City of El Paso – City Plan Commission Staff Report

Case No:	SUSU14-00011 The Paseos at Mission Ridge 3
Application Type:	Major Final
CPC Hearing Date:	March 13, 2014
Staff Planner:	Nelson Ortiz, (915) 212-1606, ortiznx@elpasotexas.gov
Location:	West of Darrington and South of Paseo Del Este
Acreage:	76.207 acres
Rep District:	East ETJ
Existing Use:	Vacant
Existing Zoning:	N/A
Proposed Zoning:	N/A
Nearest Park:	Two parks proposed within subdivision
Nearest School:	Dr. Sue Shook Elementary (.25 mi.)
Park Fees Required:	N/A
Impact Fee Area:	N/A
Property Owner:	State of Texas G.L.O.
Applicant:	Hunt Mission Ridge, LLC
Representative:	CEA Group

ATTACHMENT 3

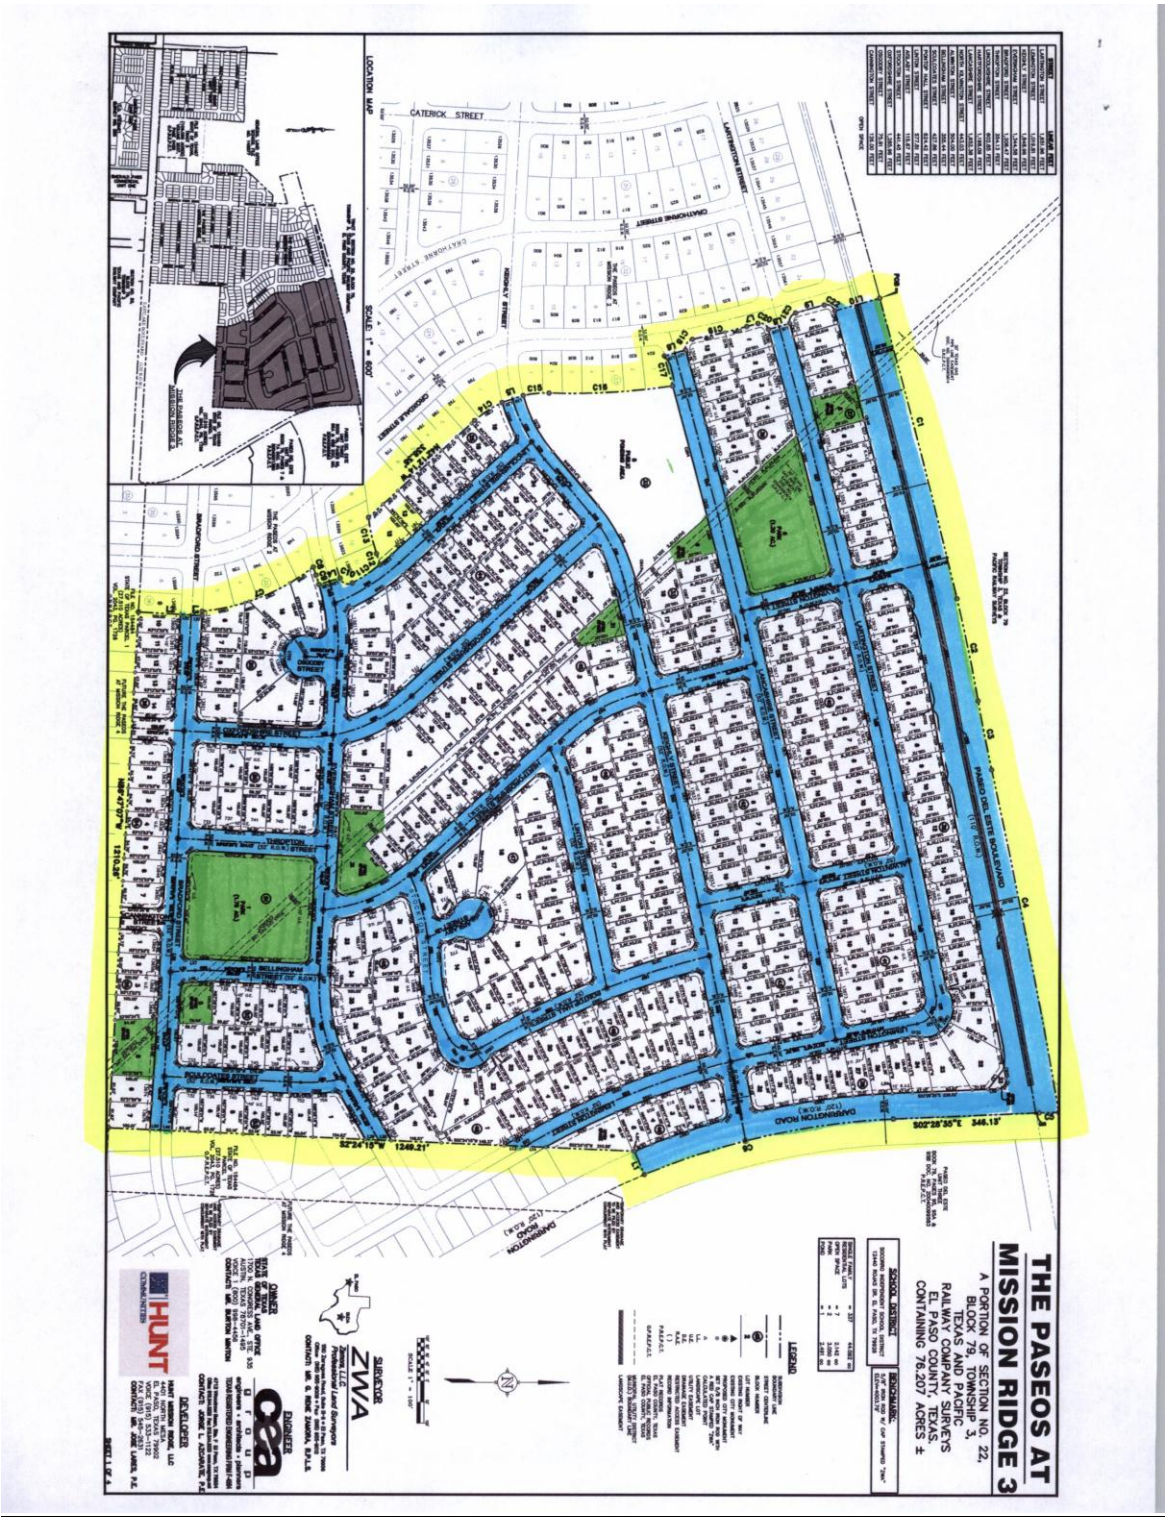
1. Clarify maintenance responsibility of entities Paseos Del Este Mud Number #1 or #8. Coordinate plat notes and dedication statement.

1. For informational purposes, the subdivision improvement plans shall also include the improvement plans for both of the proposed park sites, trails an open space areas.
